Subject: Limerick Generating Station, Unit 2  
Proposed Technical Specifications

Enclosure: Limerick Generating Station, Unit 2  
Proposed Technical Specifications

Enclosed are five copies of the Limerick Generating Station, Unit 2 Proposed Technical Specifications. This draft was developed by marking-up the Issued Limerick Generating Station, Unit 1 Technical Specifications to identify Unit 2 specific equipment tag numbers, descriptions, and design differences. Changes that were proposed but which we determined to be "improvements" or "administrative changes" were not included in the draft and may be submitted later as amendment requests.

FIGURE 3.2.1-2

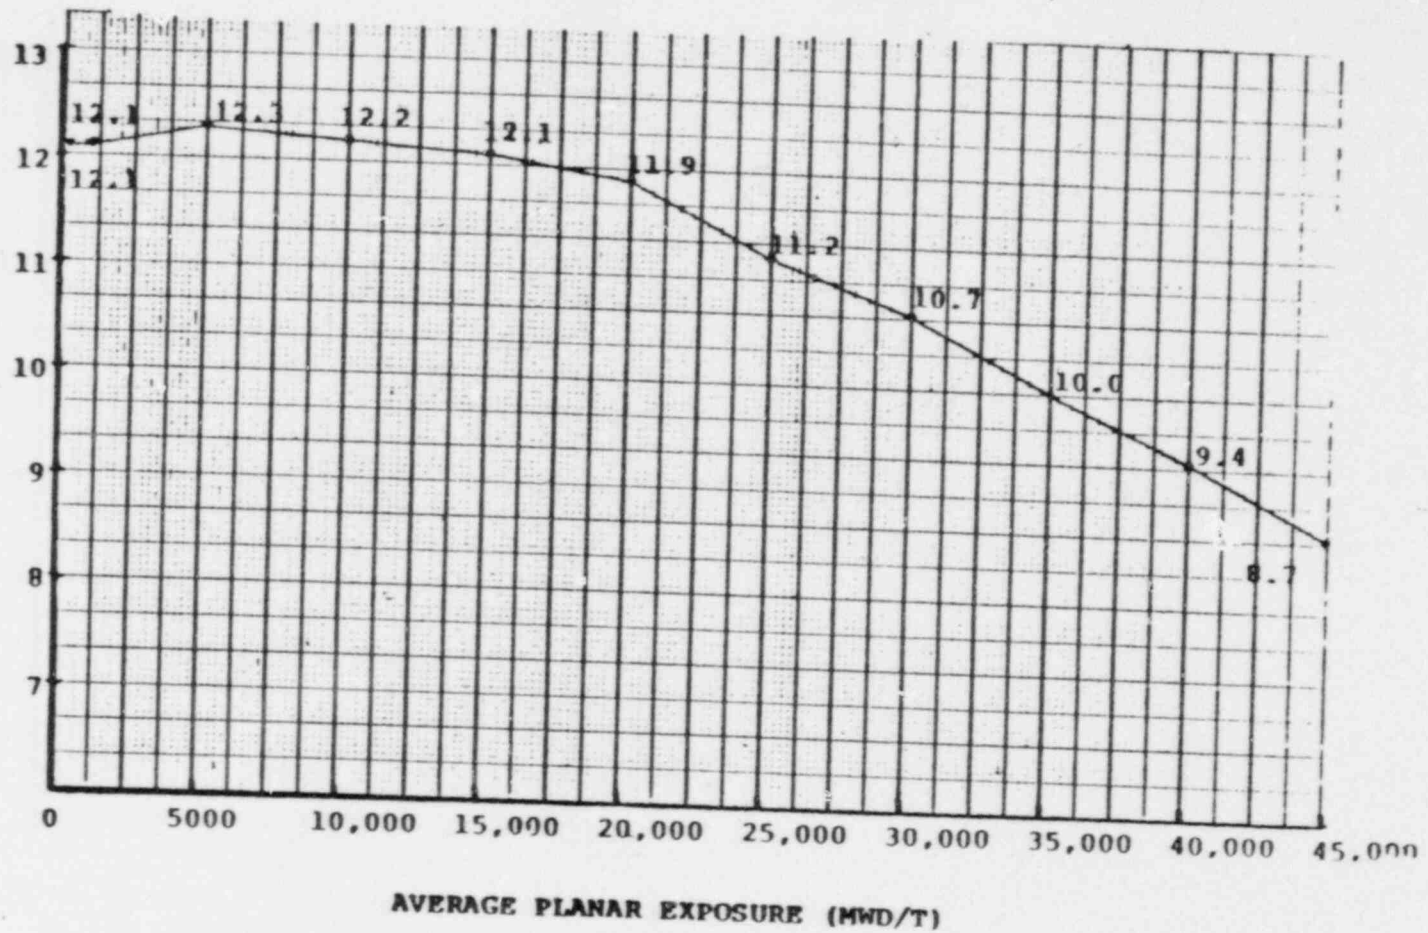
MAXIMUM AVERAGE PLANAR LINEAR HEAT  
GENERATION RATE (MAPLHGR) VERSUS  
AVERAGE PLANAR EXPOSURE  
INITIAL CORE FUEL TYPES ~~PG10240~~ *BP8CRB248*

FIGURE 3.2.1-3

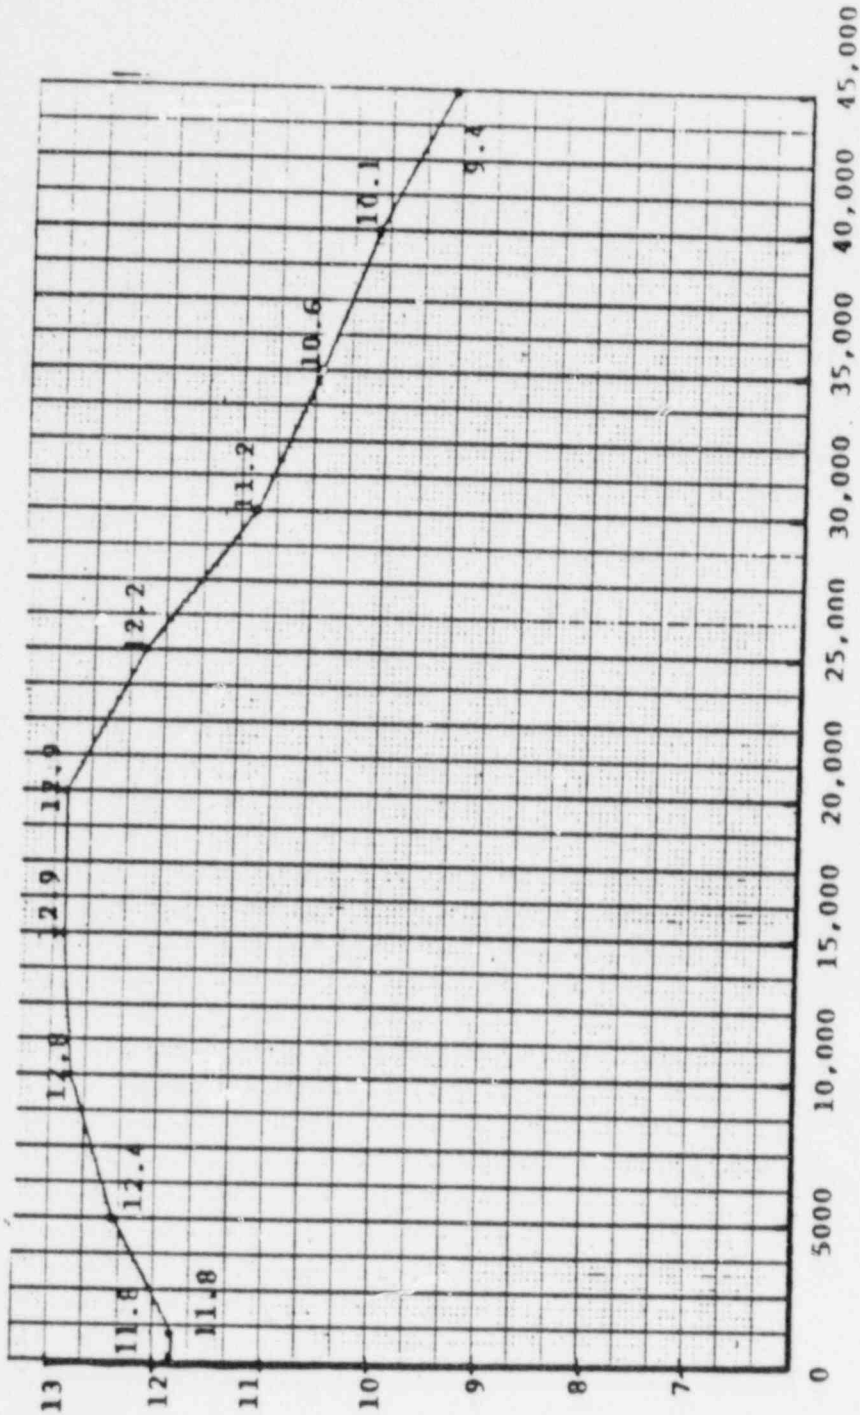
MAXIMUM AVERAGE PLANAR LINEAR HEAT  
GENERATION RATE (MAPLHGR) VERSUS  
AVERAGE PLANAR EXPOSURE  
INITIAL CORE FUEL TYPES P8C18163

*EP8CAR 163*

FIGURE 3.2.1-5

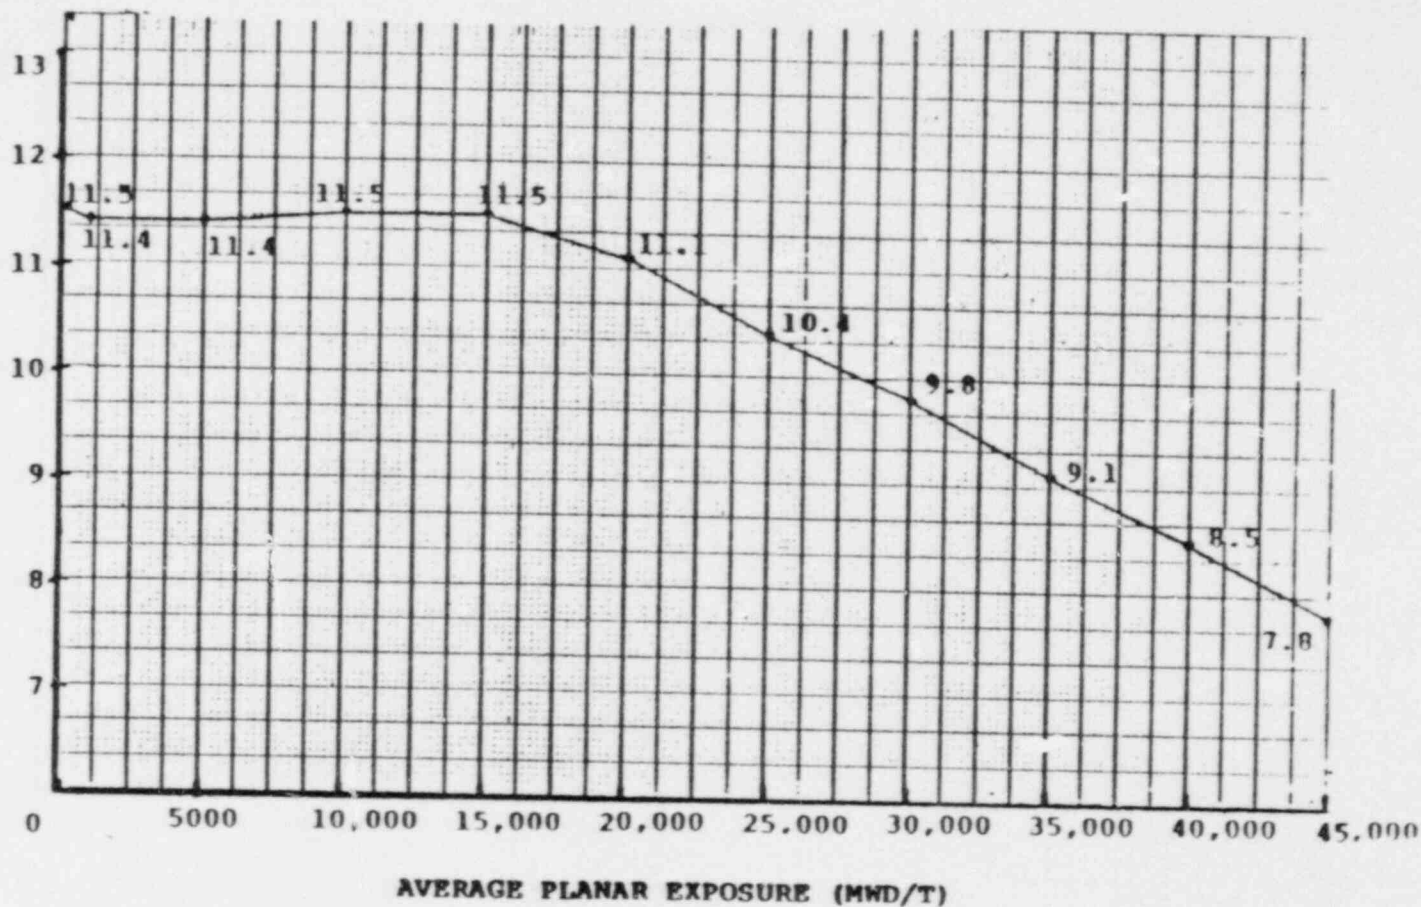
MAXIMUM AVERAGE PLANAR LINEAR HEAT  
GENERATION RATE (MAPLHGR) VERSUS  
AVERAGE PLANAR EXPOSURE  
INITIAL CORE FUEL TYPES ~~P8C1B071~~ P8CRB071

FIGURE 3.2.1-6

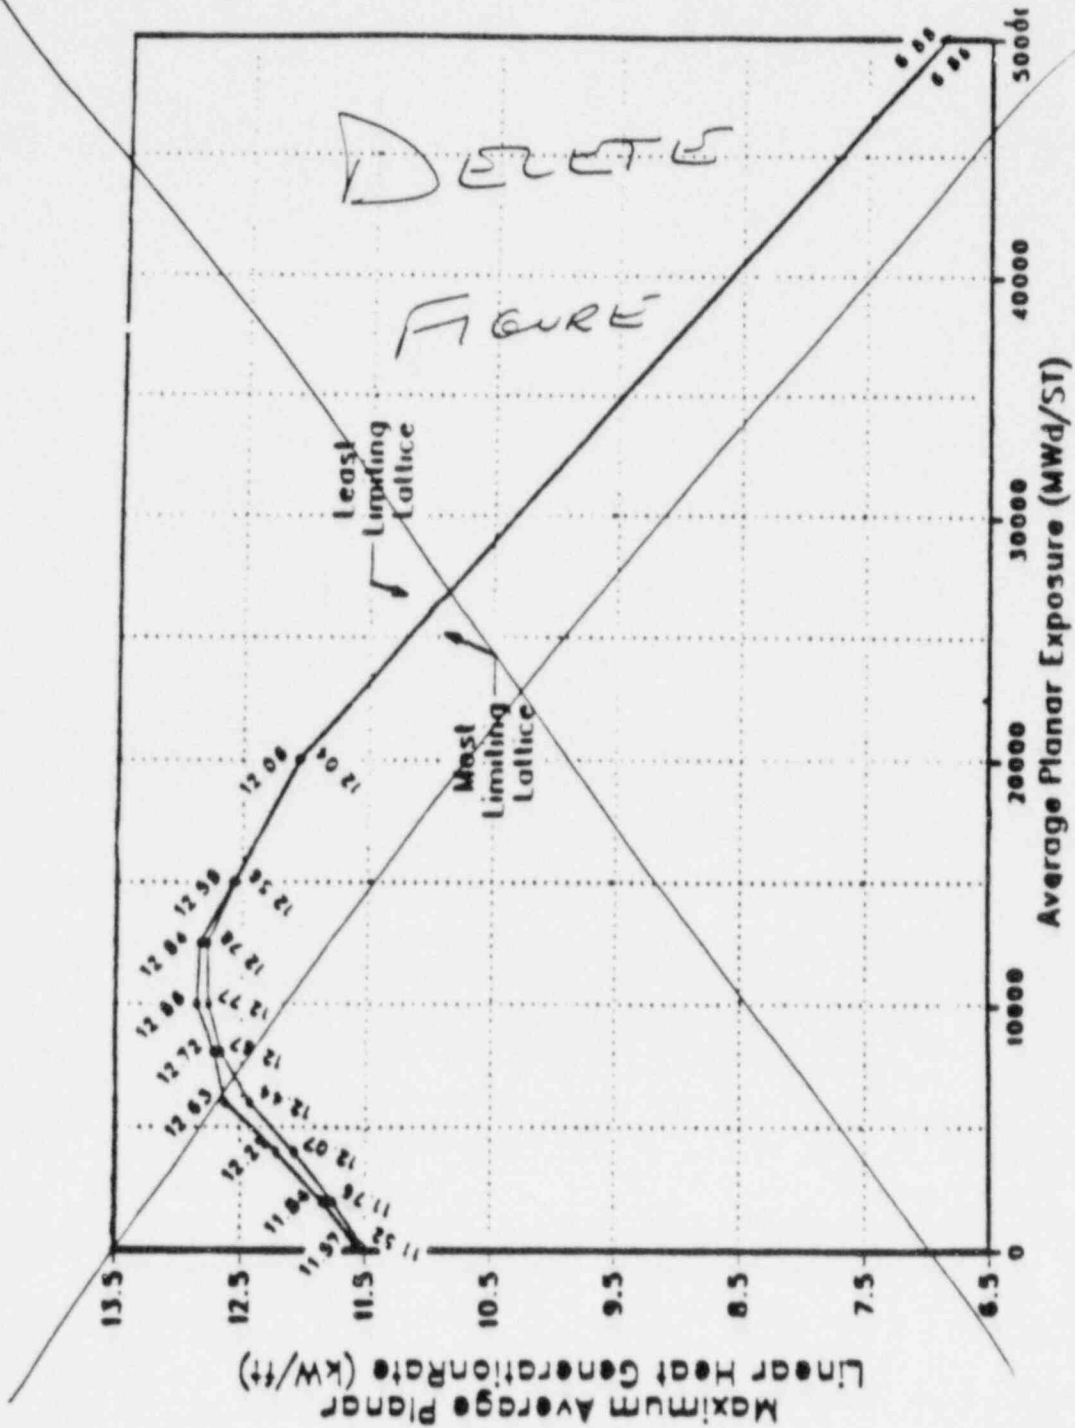
INTENTIONALLY LEFT BLANK

MAXIMUM AVERAGE PLANAR LINEAR HEAT GENERATION RATE (M4P14GR) VERSUS AVERAGE PLANAR EXPOSURE FOR FUEL TYPE BE-370A (64-BXB1B)

FIGURE 3.2.3-1a

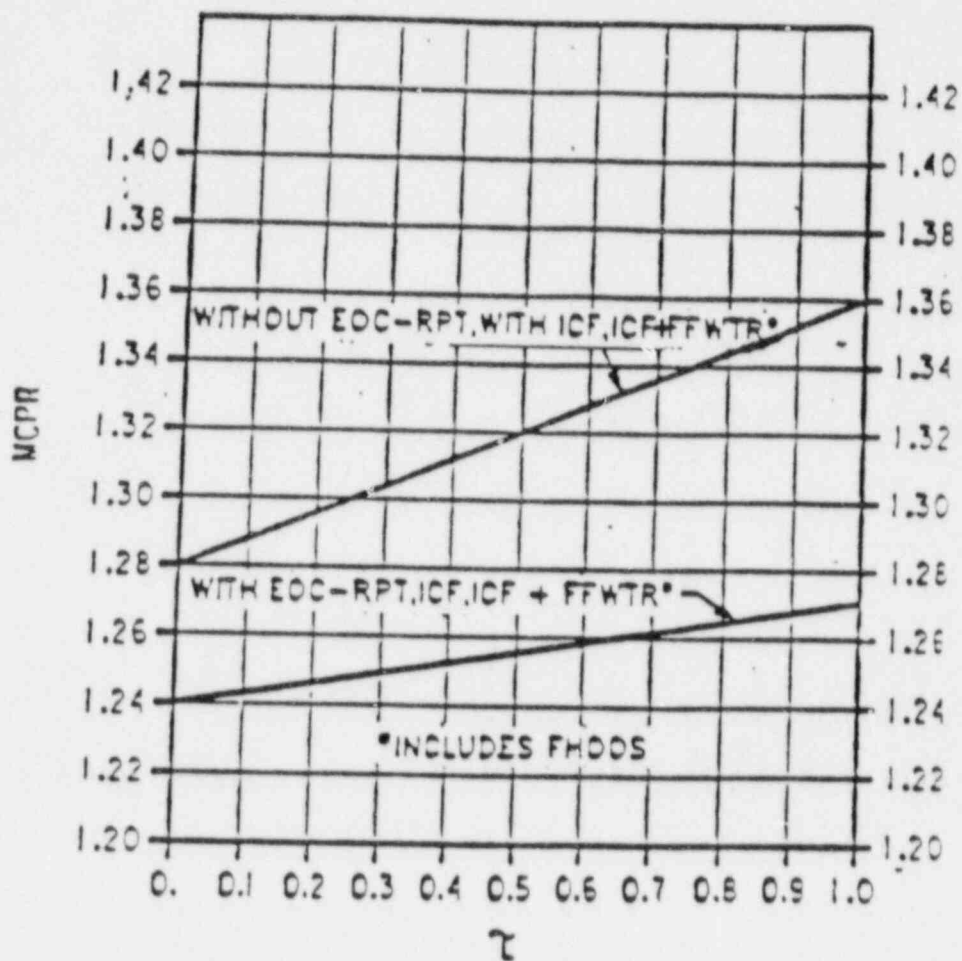
~~MINIMUM CRITICAL POWER RATIO (MCPR) VERSUS  $\gamma$  (PBXBR/BPBXBR FUEL)~~
